Staff Report

To: Salt Lake City Historic Landmark Commission
From: Caitlyn Tubbs
(801)-535-7706 or Caitlyn.Tubbs@slcgov.com
Date: April 7, 2022
Re: **PLNHLC2022-00180 Front Window Replacement 114 N F Street**

MINOR ALTERATION – WINDOW REPLACEMENT

Figure 5: Section view of proposed window, Alside Mezzo West Coast Brochure

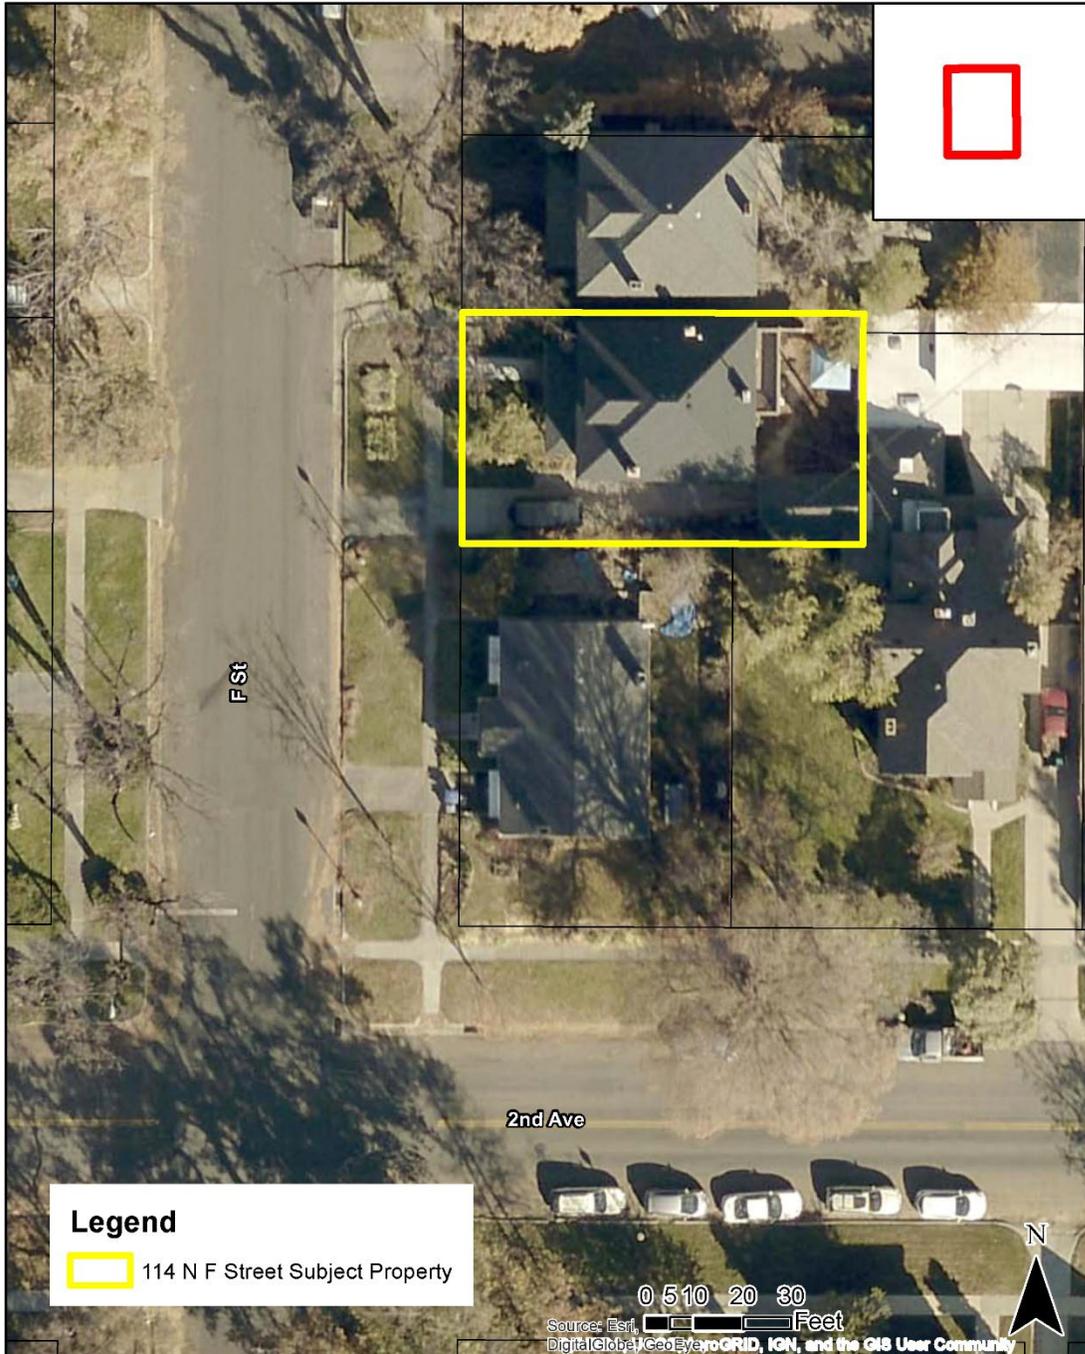
The Residential Design Guidelines encourage replacement windows to be constructed of the same material as the original windows. The original windows on the subject property are of a wood construction and the proposed windows are a vinyl material. The Guidelines allow alternative materials as long as the result will match the finish, proportions and profiles of the original but the replacement of windows on front or street-facing facades are heavily discouraged, unless they are beyond repair. As discussed previously, the proportions of the glazing for the original and proposed windows are not comparable to the historic window. The existing original windows are set shallowly into the brick and the bottom sash of the window sits closest to the brick surface. The proposed windows would have the top sash and glazing segment sitting closest to the brick surface as indicated in the section diagram to the right. Essentially, the proposed windows would be “upside-down” from the existing windows and the overall profile would be different.

In summary, the Residential Design Guidelines discourage the replacement of windows when repair is possible. In this case, the existing original windows appear to be in good condition and the Applicants and homeowners have not indicated the windows are deteriorating in this application, so Staff has found replacing the subject windows is unnecessary and unsupported by the adopted Residential Design Guidelines which follow a repair before replacement strategy. Additionally, if evidence was provided to show the windows were beyond repair, the proposed windows do not match the proportions and profile of the existing windows and are not an appropriate replacement
